Technical Memorandum

Re: Haster Retarding Basin Stormwater Treatment Process Evaluation # 9640E

This memorandum represents a technical review, opinion of concepts, and suggested modifications and alternative systems related to the February 2010 *Draft Stormwater Quality and Soils Evaluation Report - Haster Retarding Basin and Pump Station Project* prepared by AECOM. Included is a discussion of potential improvements to the suggested design features, evaluation of various alternatives, preliminary concept layouts, and rough order of magnitude construction costs.

**TYPICAL
SECTION**

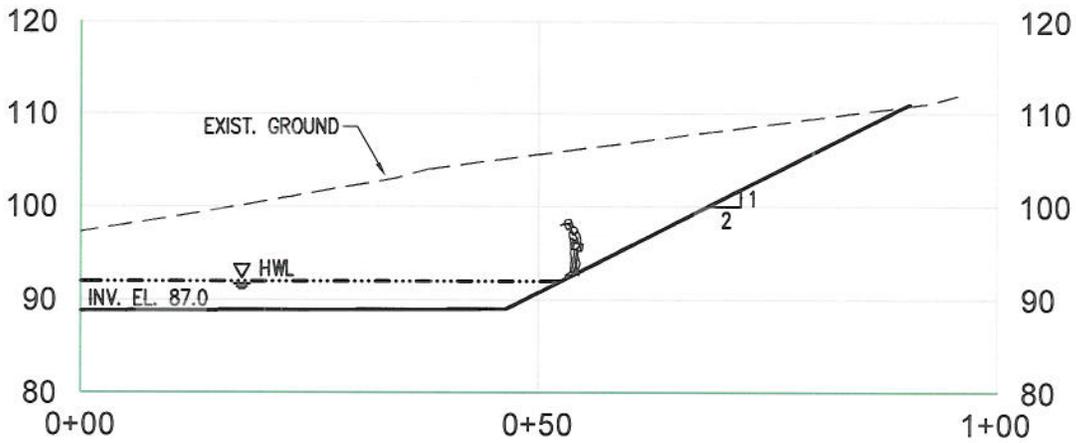
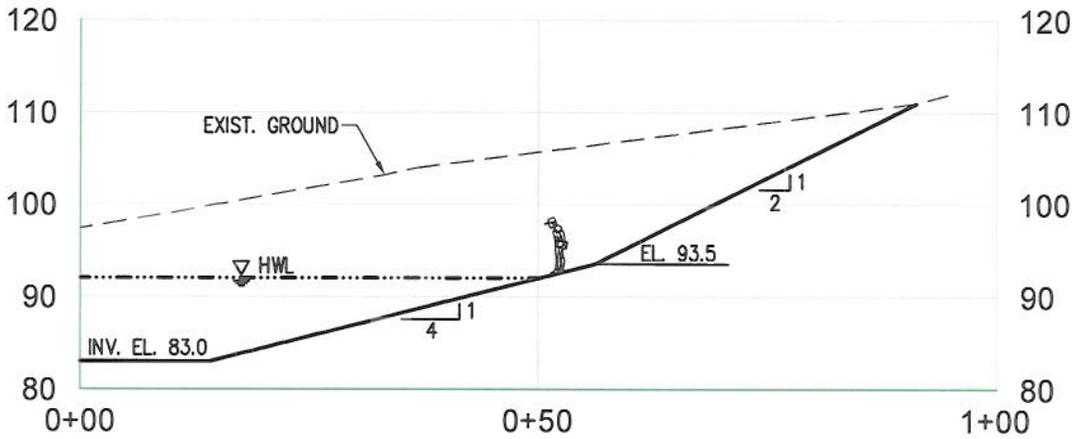
Refer to Exhibit 4 for the typical existing cross-section and proposed deepened cross-section views for the Basin. It is recommended to shallow the slope near the water surface to reduce erosion and allow for better maintenance accessibility for operations staff.

Figure 7- Modeled 100-Year 24-Hour Hydrograph Inflow and Volume

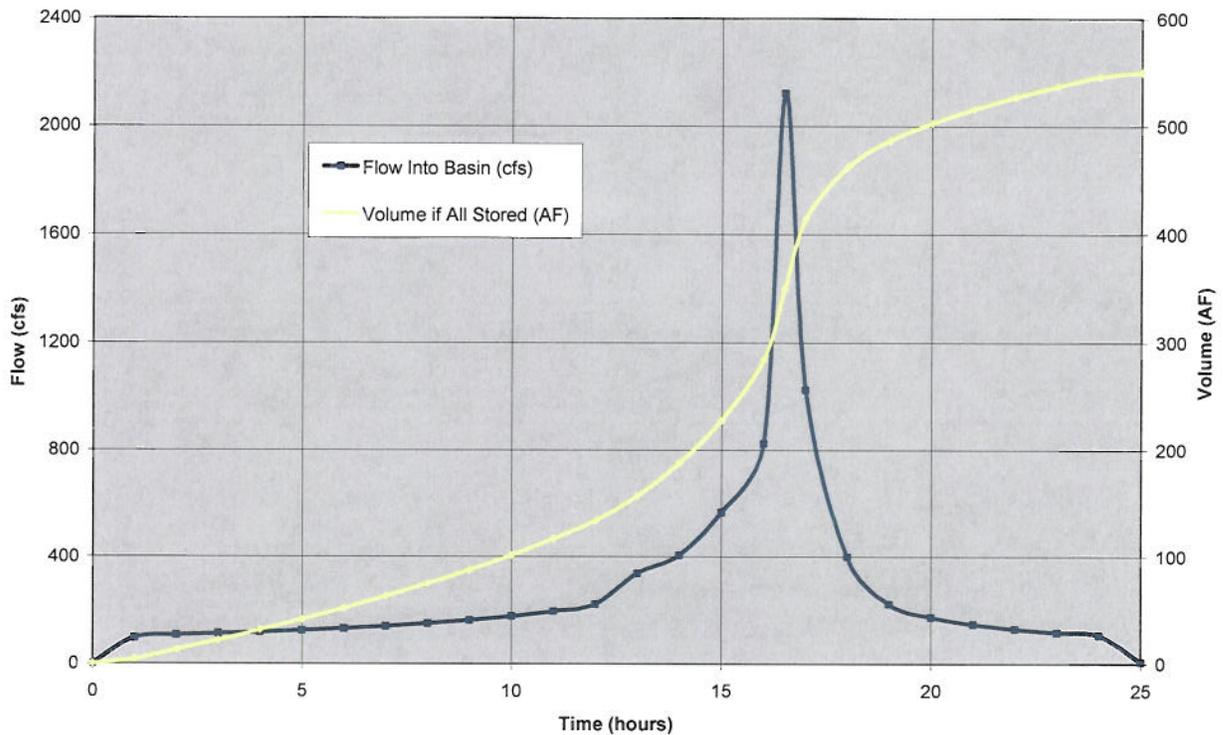
Whether the 100-year flood flows can be conveyed effectively could not be determined from the information in the report because a hydrograph was not included showing the flow versus time into the basin during such an event. We would recommend careful analysis of the required basin retention volume so that it is accurately designed and optimized for aesthetics of the park. To see if the proposed design was reasonable, we performed a rough model and analysis of the proposed basin volume versus the estimated 100-year 24-hour storm event occurring over 1850 acres of watershed in order to quickly

evaluate the suggested retention volume necessary in the Haster Basin. The calculated retention volume was then compared to the estimated retention volume from the proposed design since the finished retention volume was not listed in the report. A flood routing analysis was performed using the *County Hydrology Manual of Orange (1986)*. The results from this analysis are in the Appendix.

Figure 8 - Modeled Basin Level and Volume Using Three 133 cfs Pumps

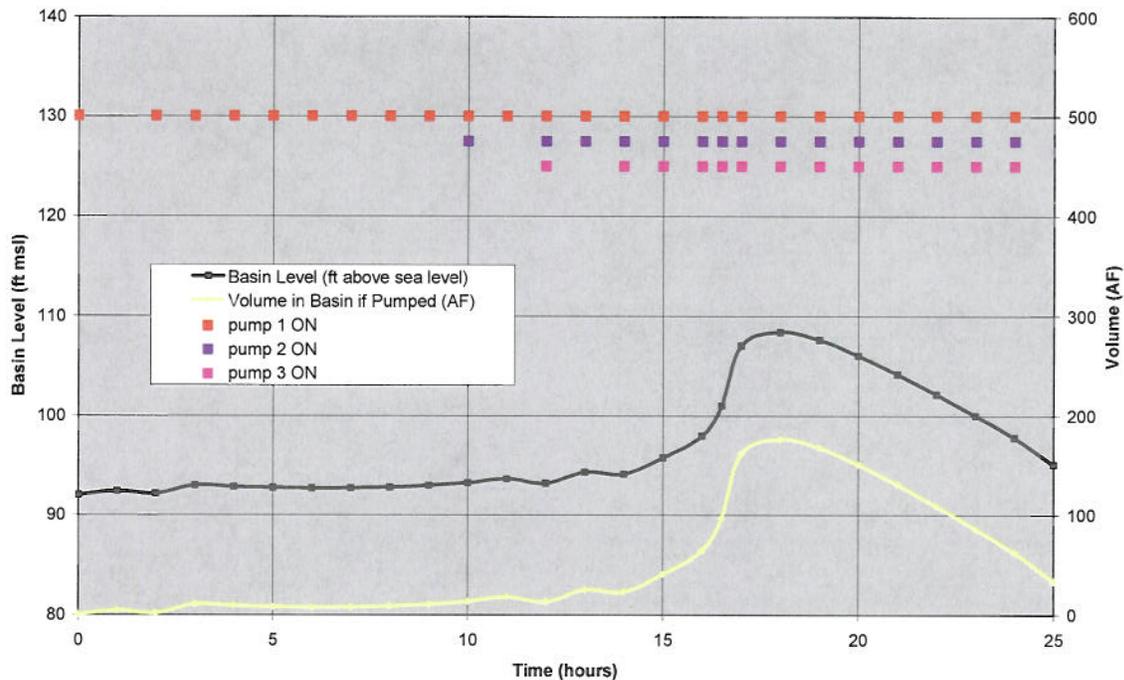
Based on Figures 7 and 8, the level in the basin is estimated to stay below 108 feet above mean sea level (msl) during a 100-year 24-hour runoff event, but only if the following is provided:

1. All three pumps are operated at low basin levels (below the main screened intake to the wet well) similar to the sequence described in the AECOM report such as pump 1 at 92.5 feet, pump 2 at 93.5 feet, and pump 3 at 94.5 feet above msl. This means all 400 cfs would need to flow through the low-flow pipe until the basin level reached the invert of the main screened intake of approximately 96 feet above msl.
2. The volume of retention storage needed above the dead storage is calculated to be about 175 AF. The average area appears to be about 850 feet by 550 feet (11 acres), based on scaling of the drawings, which provides 171 AF of retention storage below a basin level of 108' above msl. Thus, the provided retention storage volume in the AECOM report appears to be about correct.
